# CAA Environmental Assessment

Title of airspace change proposal	Inclusion of Fast Jet Area (North) into UK AIP
Change sponsor	MoD
Project reference	ACP-2020-92
Account Manager	[REDACTED]
Case study commencement date	03 May 2023
Case study report as at	05 June 2023

*Figure 1: UK FIR, Simulated Region with locations of FJA(N) (left) and FJA(S) (right), overlaid with an example of a baseline flight trajectory (green) and a rerouted trajectory scenario (red), black dots marking entry/exit points to the UK FIR*

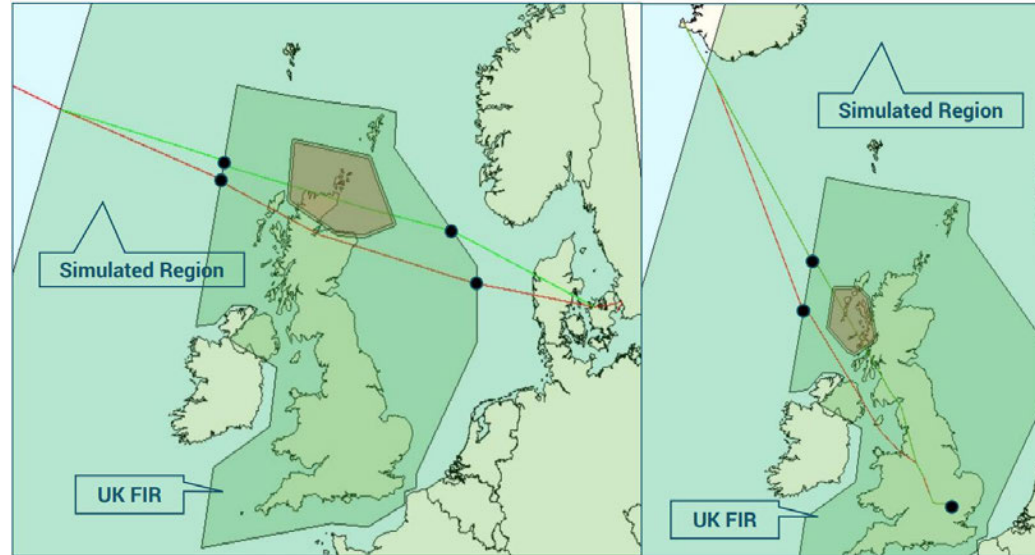
8. CO <sub>2</sub> Emissions		Status
8.1	Has the impact on CO <sub>2</sub> emissions been adequately assessed and presented in both the consultation material and the final submission to the CAA, taking account of scalability and proportionality?	YES
	<p>This ACP has been scaled as a Level M2 change with an anticipated negative impact on CO<sub>2</sub> emissions. The sponsor has therefore presented an assessment of fuel burn and CO<sub>2</sub> emissions using TAG, including annual totals and on a per flight basis.</p> <p>The environmental assessment is given in the '<i>EGDFJAN &amp; EGDFJAS Environmental Benefits Assessment (A22152 October 2022 Version 1.0)</i>' report by NATS Analytics and establishes that based on a 'worst case' scenario, the sponsor's design option will increase CO<sub>2</sub> emissions when compared to the modelled baseline values.</p> <p>This 'worst-case' scenario assumes a total of 10 activations of the FJAs with no simultaneous activation of FJA(N), FJA(S) or other MDAs. Activation times are assumed to be between 1030 to 1300 UTC.</p> <p>A Traffic Filter Region (TFR) was first defined to identify traffic whose trajectory is likely to be negatively impacted by the activation</p>

of the FJAs. All trajectories benefitting from a reroute were discounted. Further, a Simulated Region extending over a larger airspace volume was developed to account for the entire flight trajectory when changes in the Oceanic Entry/Exit Points (OEP) to the UK FIR occurred due to activation of the FJAs. The North Atlantic Tracks are therefore assumed to remain unchanged as flights reroute around the activated FJAs.

The sponsor's assessment methodology consisted of analysing historic data based on FJA activation months, day of week, Oceanic Track locations, and traffic counts to identify days representative of an appropriate traffic sample in line with post-Covid19 recovery. Five days in May-June 2022 were then selected and simulated in NEST (v1.8) in order to create sample traffic levels potentially impacted by an activation of FJA(N) and FJA(S) - 412 flights and 699 flights respectively.

The traffic sample identified was then assessed for the baseline scenario, activation of FJA(N) and FJA(S) scenarios (i.e., no reroute vs reroute around the FJAs) in terms of average track miles, fuel burn and CO<sub>2</sub>e emissions per flight which were calculated using BADA 4.2 and an emission factor of 3.18 kg CO<sub>2</sub>e per kg of fuel burn. These results were then scaled up by the average number of flights impacted per activation: 145 flights for FJA(N) and 313 flights for FJA(S)), and by 10 to give annual results depending on the 6:4 split for FJA(S) and FJA(N) usage. Projection to 2033 (10 years post implementation) was performed using Eurocontrol's October 2021 STATFOR traffic forecast until 2027 and NATS' extension thereafter.

<p>The sponsor’s assessment predicts an increase in average fuel burn per flight for FJA(N) and FJA(S) of 46 kg and 63 kg respectively, leading to an increase in average CO<sub>2</sub>e emissions per flight of 145 kg for FJA(N) and 201 kg for FJA(S). In terms of total emissions, the sponsor’s assessment predicts an increase of 491 tCO<sub>2</sub>e for 2023 rising to 585 tCO<sub>2</sub>e by 2033, an annual increase of 0.13% from baseline values. For the appraisal period between 2023 – 2033, this will amount to an estimated total increase of 5,972 tCO<sub>2</sub>e.</p> <p>The sponsor has also presented a TAG assessment using DfT’s Greenhouse Gases Workbook (version May 2022). The latest version of the workbook is from May 2023, however differences in monetised results using the updated workbook are negligible.</p> <p>The assessment also considers 1% of total emissions as traded based on flights whose origin and destination are within the EU (i.e., the older EU Emissions Trading Scheme (ETS)). However, following the implementation of the UK ETS, routes eligible for trading include UK domestic flights, flights between the UK and Gibraltar, and flights departing the UK to European Economic Area (EEA) states conducted by all included aircraft operators, regardless of nationality. The sponsor has stated that the location of the FJAs have an impact on Oceanic air traffic routes including all commercial airlines routing to and from North America/Europe and therefore has assumed a majority of flights (99%) ineligible under the older EU ETS. Given that the scope of the UK ETS is similar to the scope of the older EU ETS, it is considered that a change from the 1% considered as traded emissions is unlikely to be substantial.</p> <p>An updated version of Eurocontrol’s STATFOR traffic forecast from March 2023 for the 2023 to 2029 period is also available. However, the traffic growth rate in latest version is similar to the one considered in the sponsor’s assessment and therefore a reassessment using the March 2023 forecast is unlikely to show any significant differences.</p> <p>Three recommendations have therefore been proposed in order to address the observations above (see Question 17.1).</p>

17. Recommendations/Conditions/PIR Data Requirements		Status
17.1	Are there any Recommendations which the change sponsor <b>should try</b> to address either before or after implementation (if approved)? If yes, please list them below.	YES
	<p>The sponsor should try to address the following recommendations before implementation of the ACP (if approved):</p> <ul style="list-style-type: none"> <li>• Update the traffic forecasts using the most up-to-date and credible, clearly referenced sources of data</li> <li>• Confirm the share of traded and non-traded emissions under the UK ETS applicable to the TAG assessment for CO<sub>2</sub> emissions</li> <li>• Update the CO<sub>2</sub> calculations and TAG assessment for CO<sub>2</sub> emissions using this updated traffic forecast, share of traded and non-traded emissions considered, and using the most up-to-date version of the DfT's Greenhouse Gases Workbook</li> </ul>
